Amdt. Dated: March 13, 2006

Amendments to the Drawings:

ATTACHMENTS: 1 ANNOTATED SHEET AND 2 REPLACEMENT SHEETS

ANNOTATED SHEET antenna , 52 spread spectrum code generator demodulator 60 62 demodulator digital \$8 bandpass filter fuzzy logic Embedded Fuzzy Logic Coding Algorithm Membership decoder channel **LOW HIGH** 66 decode 68 dac 70 lowpass filter power amp

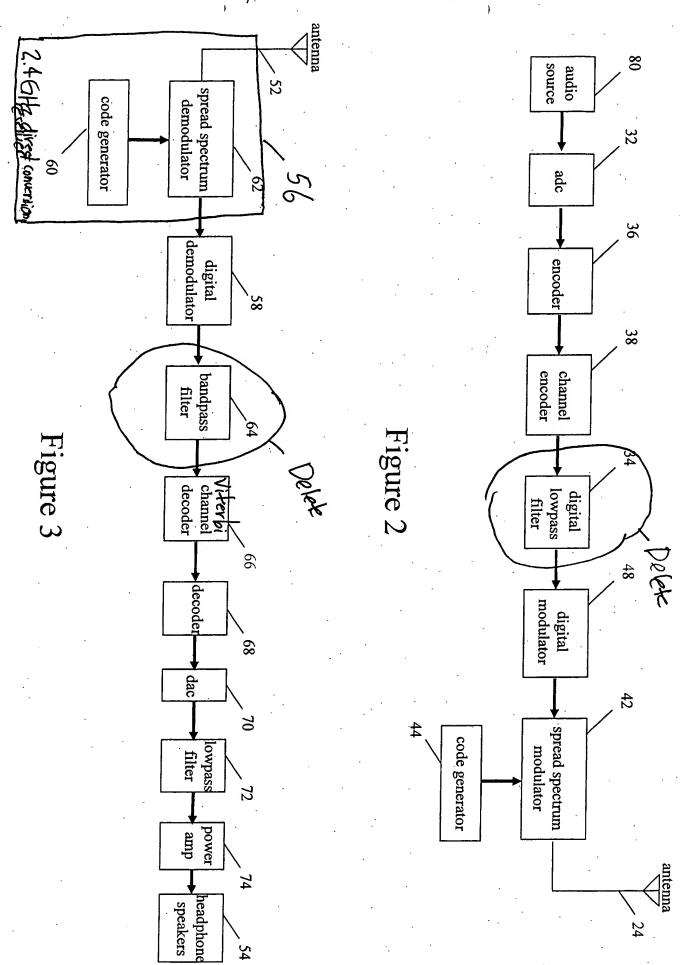
The drawings were objected to as incorporating new matter because of the altered

order of the filter in relation to other elements. Corrected drawings were required

because of the altered order of the filter in Figs. 2 and 3. More particularly, with respect

to Fig. 2, the low pass filter was shown between the ADC and encoder, thus differing

from the drawings in the parent application. With respect to Fig. 3, the bandpass filter

was shown in a different order from that shown in the parent.

Moreover, Applicant has specified in Fig. 3 that the channel decoder 66 is a

Viterbi channel decoder. Also in Fig. 3, Applicant has specified that the receiver is a

direct conversion receiver. Each of these elements was originally found in Applicant's

In order to expedite matters, Applicant has deleted the low pass filter of Fig. 2 as

well as the bandpass filter of Fig. 3. These filters are often included with analog-to-

digital converters and demodulators such as those shown in Figs. 2 and 3.
